**Site: 50 Prospect Street**

**Case #: PB 2019-07**

**Date: July 11 August 14, 2019**

## STAFF REPORT

### **Shadow Study**

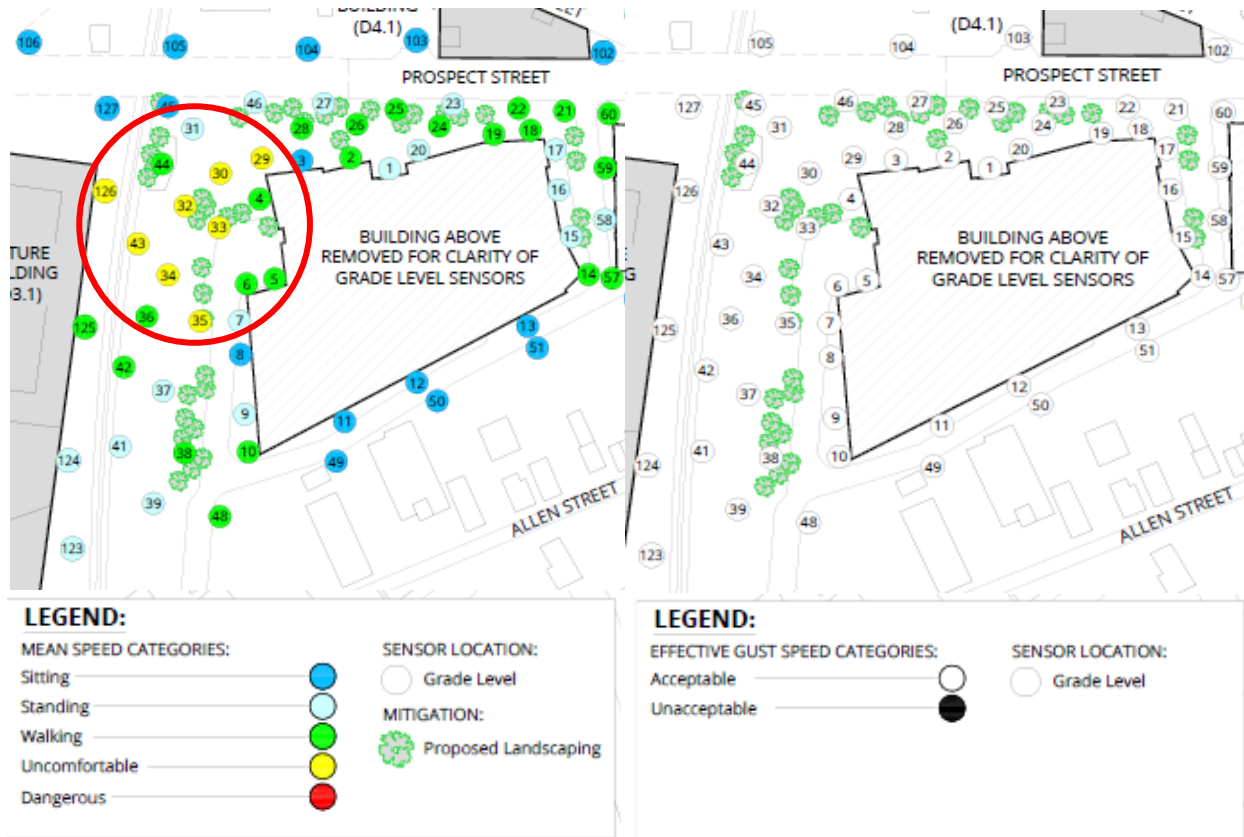
The Applicant submitted a shadow study prepared by Ground as part of the application which illustrates shadows at the spring and fall equinox, summer and winter solstice, and the cumulative new shadows. During favorable weather, like the summer solstice and fall equinox, when people are expected to be hanging out on the plaza; it will be in shadow during the morning hours and in full sun (with the exception of the shadow from the bridge) during the afternoon and evening hours. Sidewalks surrounding the project site will be shadowed intermittently. The most impacted are sidewalks north of the project site including Bennett Court between D2.1 and D2.2 and Somerville Avenue north of D2.1 which is typical in New England.
